SYDNEY NORTH PLANNING PANEL

Panel Reference	2018SNH010 DA
DA Number	DA214/2017/2
Local Government Area	North Sydney Council
Proposed Development	Section 4.55(2) to modify Consent No 214/17 with regard to lowering the hall into the ground by 3m; minor internal design alterations; increasing side setbacks to multi-purpose hall; school signage, landscaping; change to windows and door on Level 1; change to materials and colour scheme.
Street Address	149 West Street CROWS NEST NSW 2065
Applicant	The NSW Department of Education C/O Urbis P/L
Owner	The NSW Department of Education
Date of DA lodgement	21 February 2018
Number of Submissions	Three (3)
Regional Development Criteria (Schedule 7 of the SEPP (State and Regional Development) 2011	S4.55(2) Modification Application of development with Capital Investment Value (CIV) exceeds \$5 Million – Crown Development
List of All Relevant s4.15(1)(a) Matters	Environmental Planning & Assessment Act 1979 Disability Discrimination Act 1992 SEPP (Educational Establishments and Child Care Facilities) 2017 SEPP 64 (Advertising and Signage) SEPP (Infrastructure) 2007 North Sydney LEP 2013 North Sydney DCP 2013

EXECUTIVE SUMMARY

Figure 3: Depiction of new illuminate sign

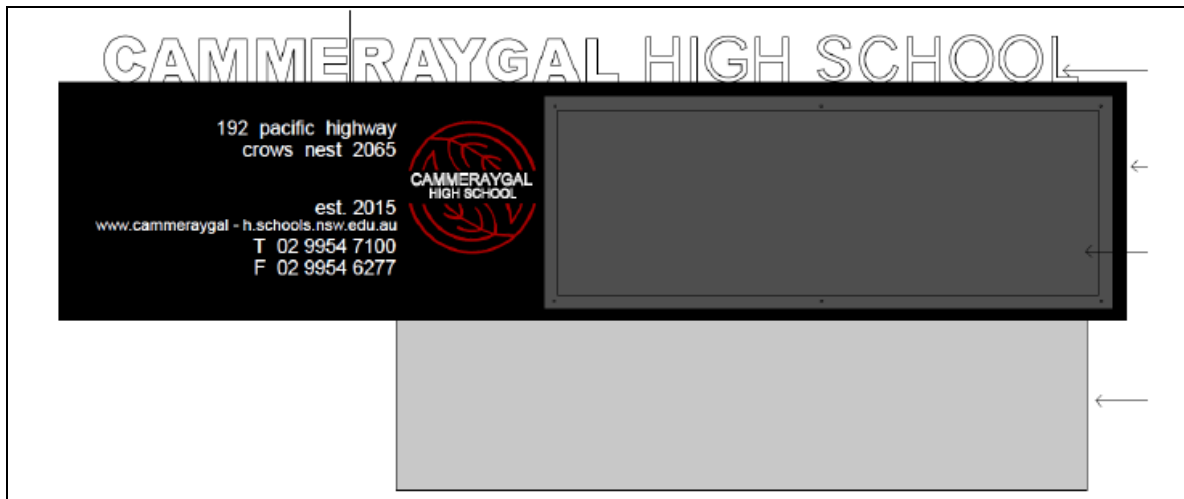
Planning Comment: the revised signage will now comprise an illuminated and interchangeable signage for general school announcements. Such signs are now typical of NSW schools. Condition 31 for no illumination is recommended for removal as per the applicant request however there are two new standard conditions recommended to be imposed to regulate content, illumination hours and intensity and content.
